**Addendum No. 2**  
**March 15, 2018**

Project: **Lincoln High School – Window Replacement & Miscellaneous Renovations 2018 PD #3150**  
Sioux Falls, South Dakota  
Project No.: 2763

Architect: Architecture Incorporated

12) DRAWING SHEET 4.40 – ENLARGED RESTROOM FLOOR PLANS

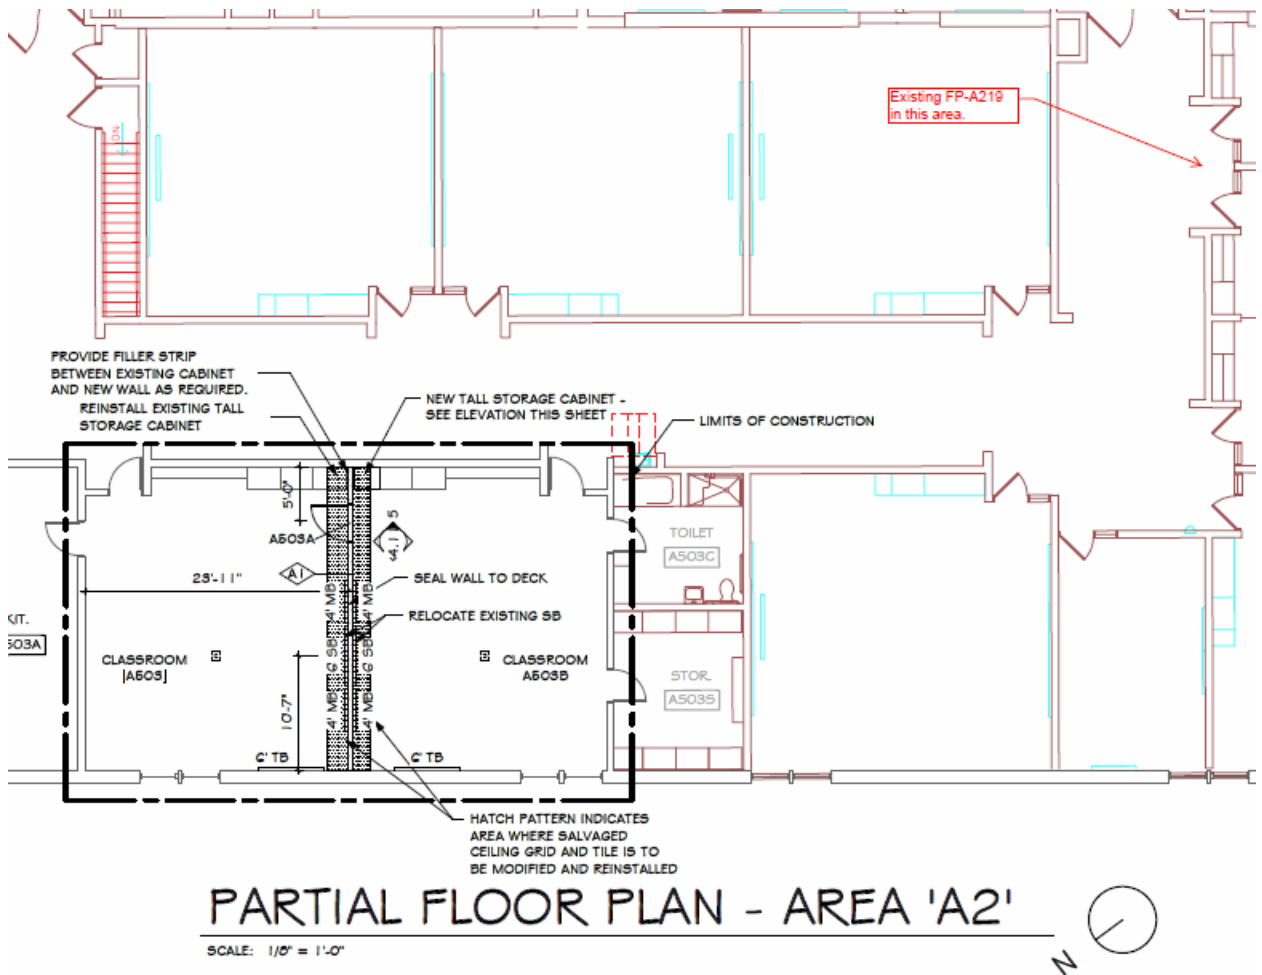
- a) Reference Enlarged Toilet Room plan – provide 2” cmu soap enclosure as required to conceal existing column at west wall of Room B111C.
- b) Reference Toilet Accessory Schedule – Omit ALL occurrences of Note 6 in the Toilet Accessory Schedule.

- i) Toilet accessory Item E should be keynoted with Note 8.
  - ii) Toilet accessory Items H & M should be keynoted with Note 5.
  - iii) Toilet accessory Items A, B, C, D, F, J & R shall not have any keynotes associated with them.
- c) Provide fire rated acoustical panel ceiling enclosures above mechanical, electrical and plumbing items that penetrate the rated ceilings at rooms B111A, B111B and B111C.

Associated Consulting Engineering, Incorporated	PROJECT	PROJECT NO.	SHEET
		LINCOLN HIGH SCHOOL	117136	R8. 30
		2018 RENOVATIONS	DATE	
		FLOOR PLAN AREA B - HVAC	3-15-18	DRAWN BY
			NJH	1 OF 1

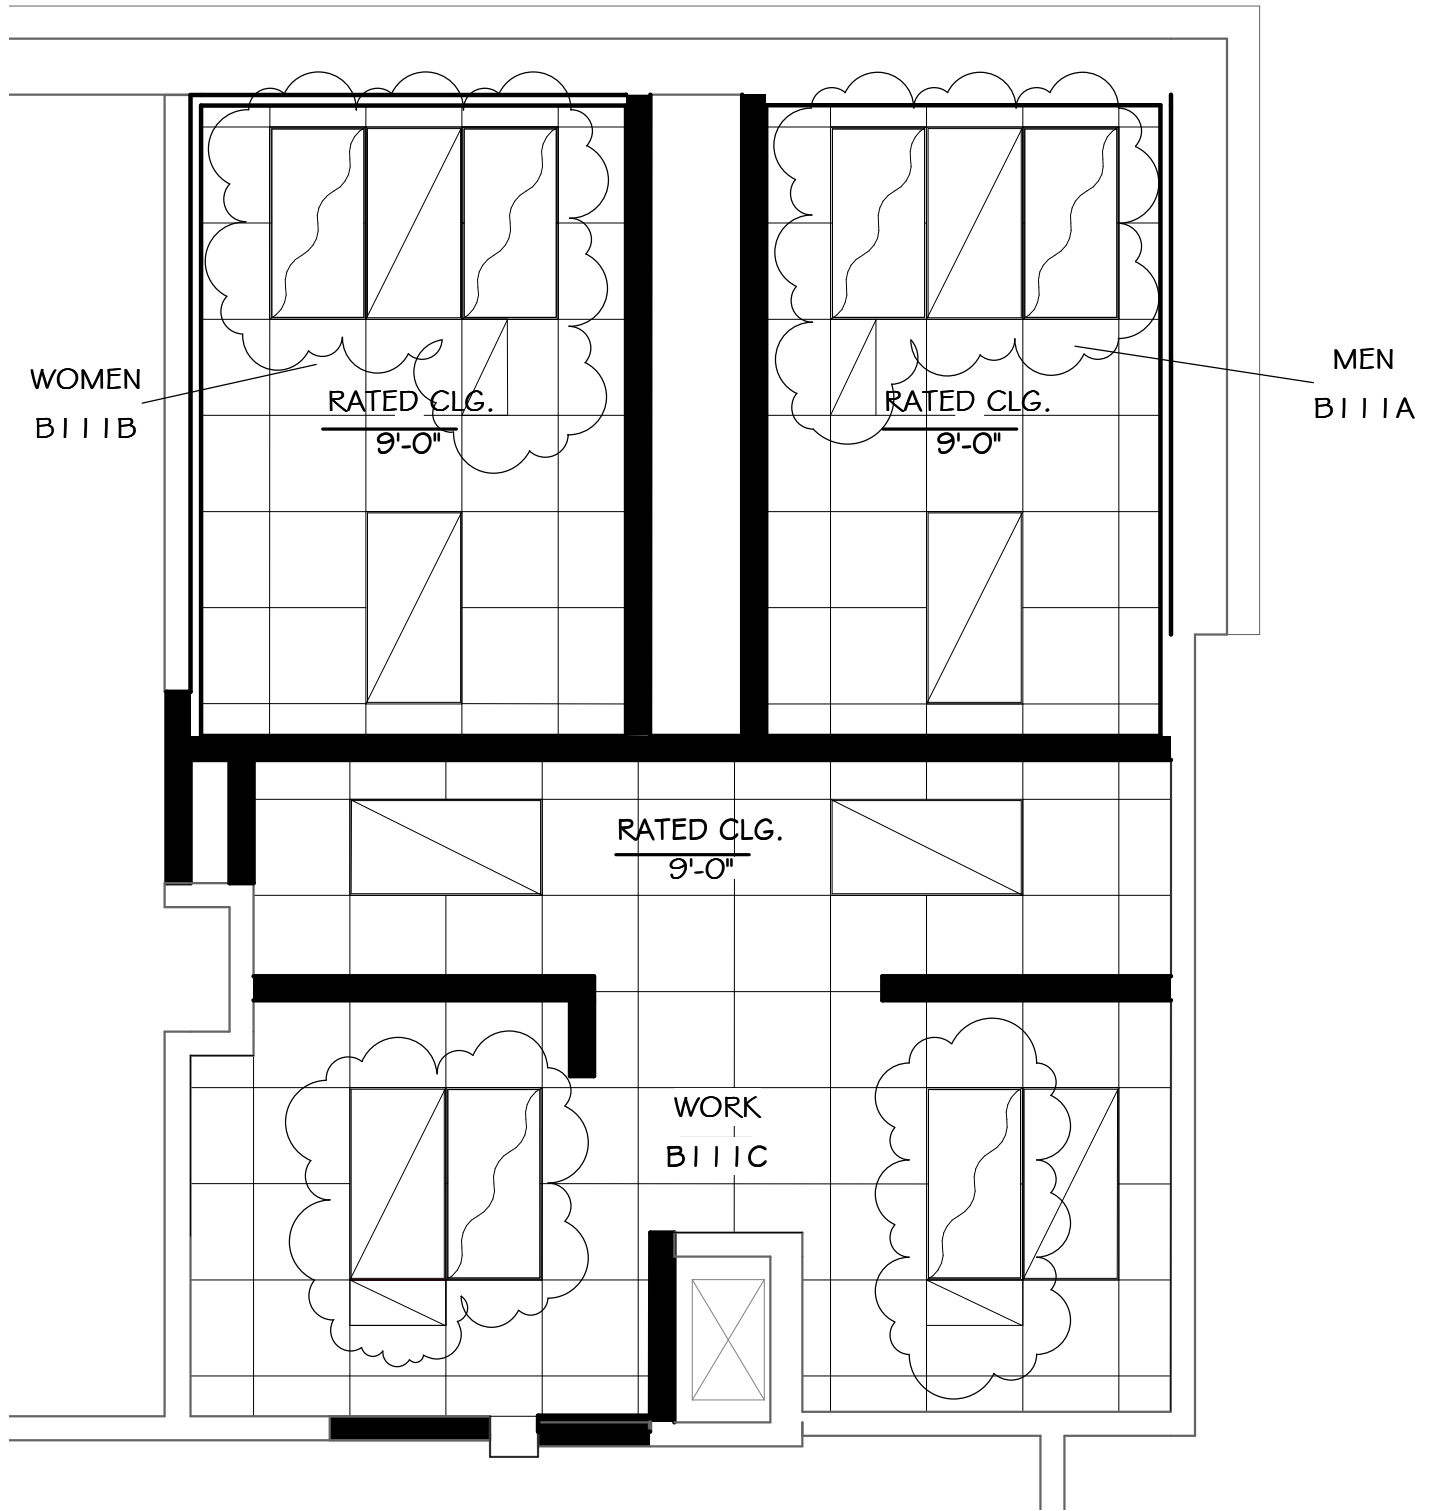
- a) Replace exhaust grilles to accommodate new ceiling and provide fire dampers. Refer to revised drawing sheet R8.30, dated 03-15-18 attached to the end of this addendum.
- b) Area “A2”: Disconnect and re-connect FP-A112 (being relocated and re-named to FP-A503), extend/reroute existing raceways and conductors as required.
- c) Area “A2”: Provide connection to FP-A211, connect to the 277V branch circuit serving existing FP-A219 (see below for location).
